Determination 2019/010

Regarding the code compliance of an intertenancy wall in an apartment building with respect to sound transmission, at 200 Pilkington Road, Point England, Auckland

Figure 1: Layout of units 5 and 6 – the intertenancy wall is shown as a heavy dotted line (not to scale)

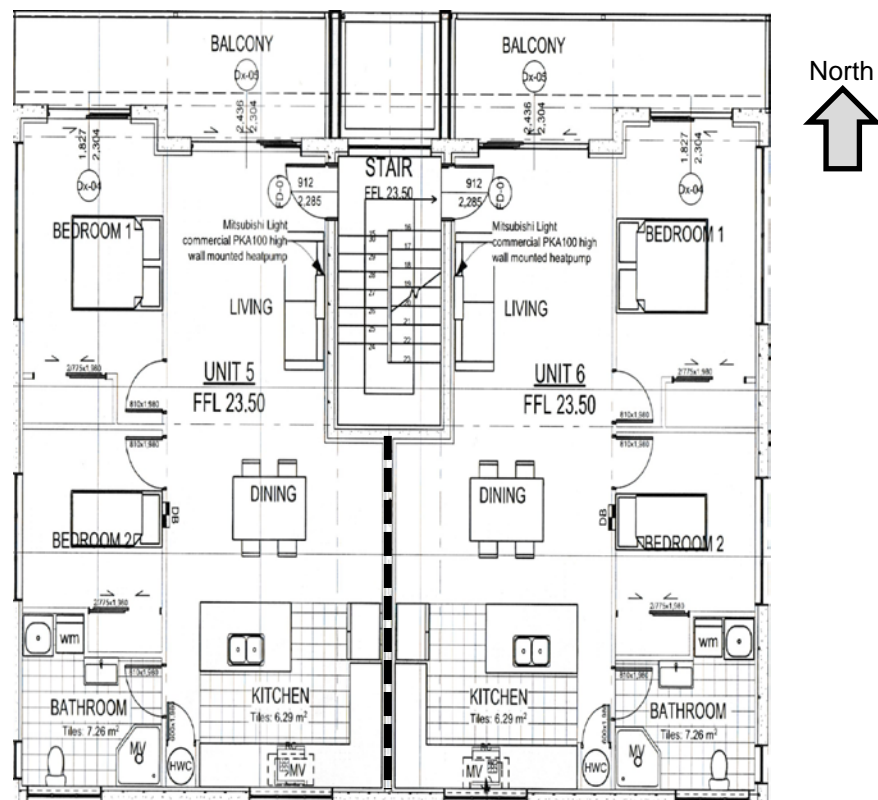
- 2.1.4 Units 5 and 6 are on the third storey of the building. The unit 5 and 6 intertenancy wall runs from the stairwell to the south of the building. The kitchen and dining room are adjacent to the unit 5 and 6 intertenancy wall in both units.

4.1.4 The reports provided by the applicant confirm the unit 5 and 6 intertenancy wall does not meet Clause G6.3.1 of the Building Code because the FSTC ratings achieved were 46dB in the first test, and 47dB in the second test.

4.2.6 The second acoustic engineer's view is that 3dB is considered the smallest change noticeable to the average person, and that the wall "in fact performs quite well". The decibel (dB) scale is logarithmic and not linear. An increase of 3dB represents a doubling of sound intensity, or acoustic power. It is a noticeable difference in noise level and I do not consider the 3dB shortfall can be treated as insignificant. 50dB is the minimum level of acoustic separation required between occupancies under Clause G6.3.1 when applying the sound transmission field test cited in G6/VM1, and I do not consider it reasonable in this instance to modify Clause G6.3.1 to lower that minimum figure.

5.1 In accordance with section 188 of the Building Act 2004, I hereby determine that the unit 5 and 6 intertenancy wall does not comply with Building Code Clause G6.3.1.

5.2 In regards to the proposed modification to the Building Code for Clause G6.3.1, I determine that the authority was correct to refuse to grant a modification of Clause G6.3.1 for building consent number B/2016/4706.
